**RE: Response to Preliminary Adequacy Comments, Section 20 Mine (M-2022-001), TR-1  
Withdrawal of TR-1 in part**

This letter is the response of applicant Red Tiera Equities, LLC, to the Division's May 3 letter concerning preliminary adequacy review of TR-1 at the Section 20 Gravel Mine (M 2022 001). The applicant appreciates the Division's thorough review, and provides responsive information below for each point in the Division's letter.

SECTION 20  
DRMS 112 RECLAMATION PERMIT  
GILCREST, COLORADO

EXHIBIT C-1

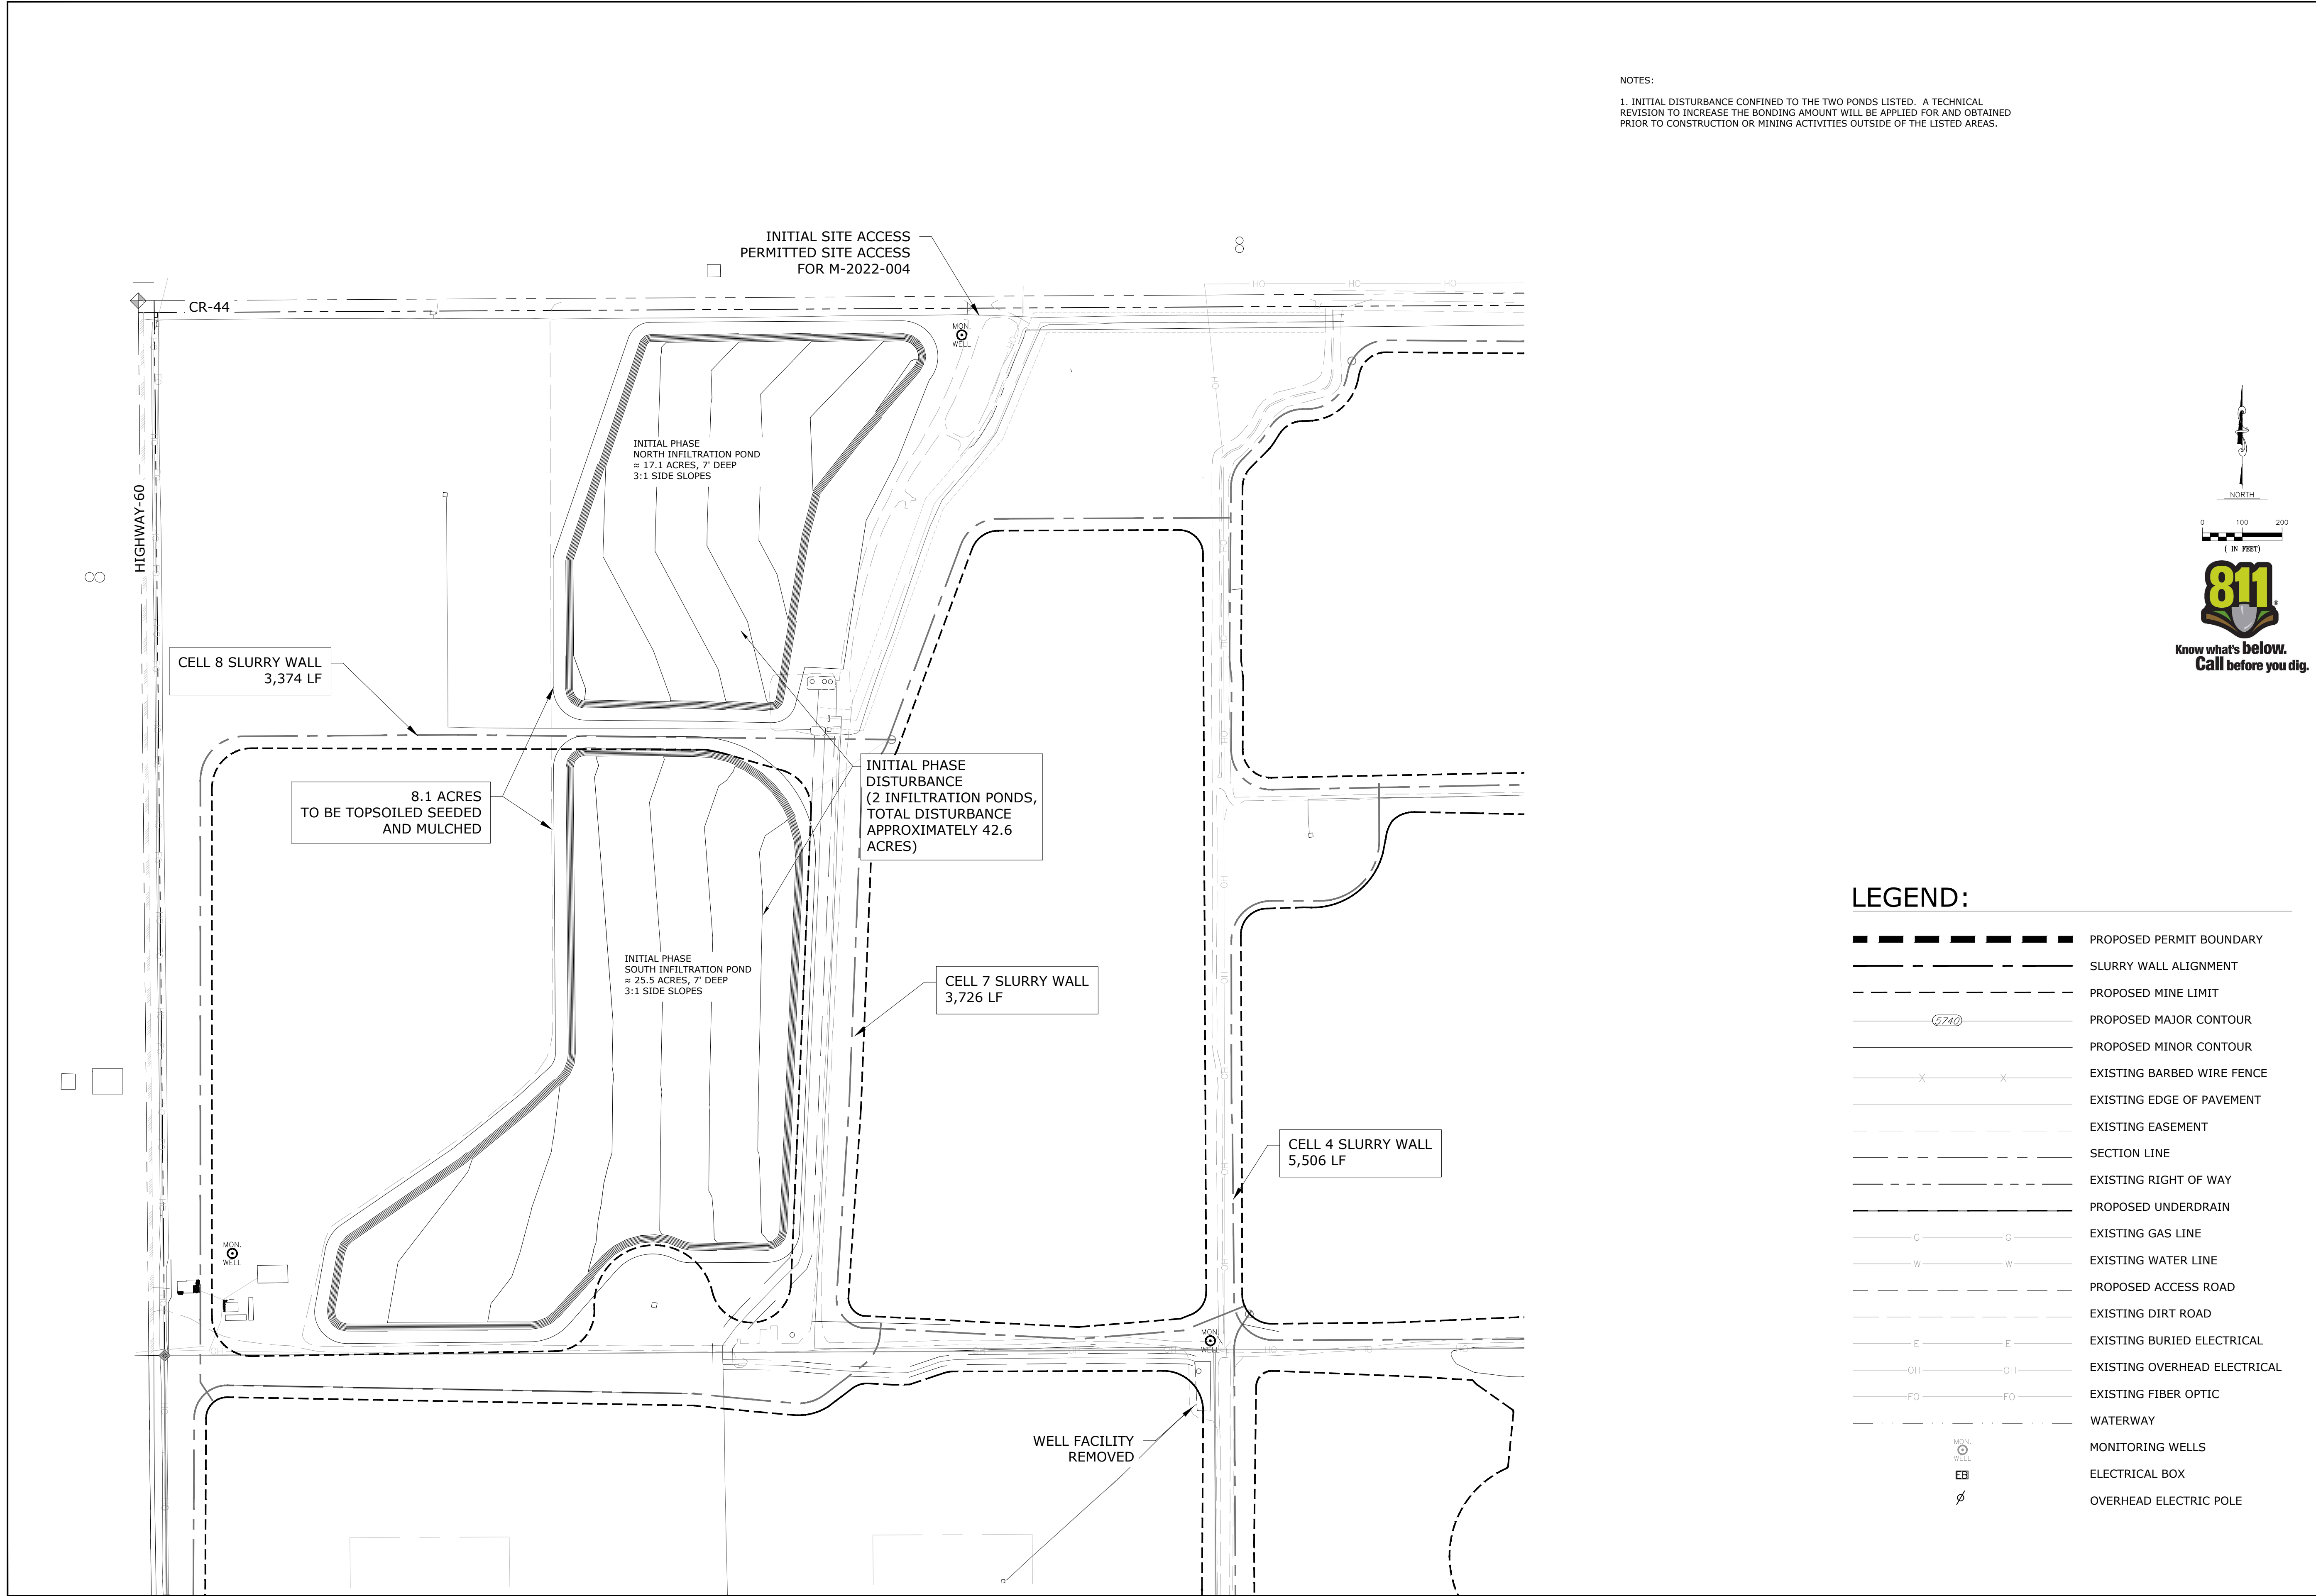
4. Please update the Pre-Mining Plan Map (Exhibit C-1) to clearly show the permit boundary of the Section 20 Mine (111) M-2022-004 and other areas that may have changed the topography of the affected land to date within the permit boundary of M-2022-001.

**The Division's request is relevant to the 112 permit (M-2022-001) and this TR to the extent that the 111 operation modified the site in a way that changes mining technique, reclamation slopes, or produces some other quantifiable impact on bonding. Such an impact is not readily apparent in this case, as removal of fill materials for the 111 government contract essentially pre-stripped a small amount of the site of overburden. However, the Pre-Mining Plan Map will be modified as requested in the interest of consolidating all current and future Reclamation Permit issues under M-2022-001 and facilitating the immediate release of any remaining M-2022-004 liabilities.**
